## THE CITY OF DURHAM TRUST

29 July 2022

DM/22/01981/RM: Reserved matters application for 470 dwellings (appearance, landscaping, layout and scale) pursuant to DM/20/03558/OUT, land to the east of Regents Court,

Sherburn Road, Durham City

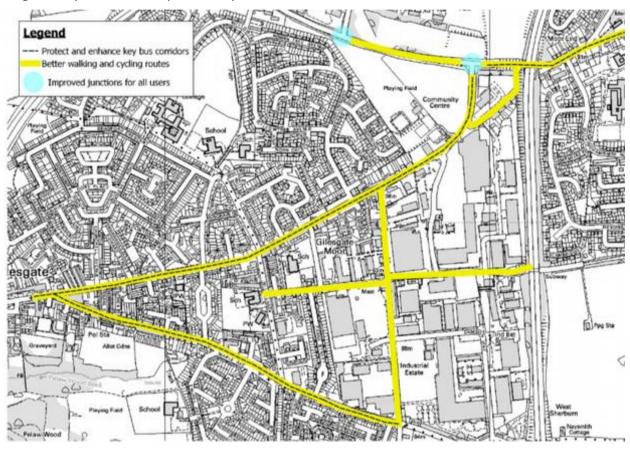
The Trust was critical of the approved Masterplan with its lack of clarity regarding which internal paths and external connections would be suitable for cycling. It appears from the submitted plans that the Reserved Matters application has provided no cycle paths within the site. The outline application envisaged a cycle route linking Bent House Lane and Damson Way, potentially rerouting the National Cycle Network Route 14. Here below are the sorry remains of that proposal, highlighted in green on an extract of the submitted site plan.

In contrast with the approved 'Masterplan' the route is now illegible, disjointed, and clearly no wider than the 1.8m footways. It does not appear to be intended as a cycle route, and nor do any of the other connections to Bent House Lane. At Sniperley Park the County Council's response to the developers includes mention of separating cycle and walking paths to comply with LTN 1/20. The Trust suggests that the connections onto Bent House Lane and other links within the site should have cycle paths at carriageway level, with pedestrian paths alongside at footway level to avoid conflict.
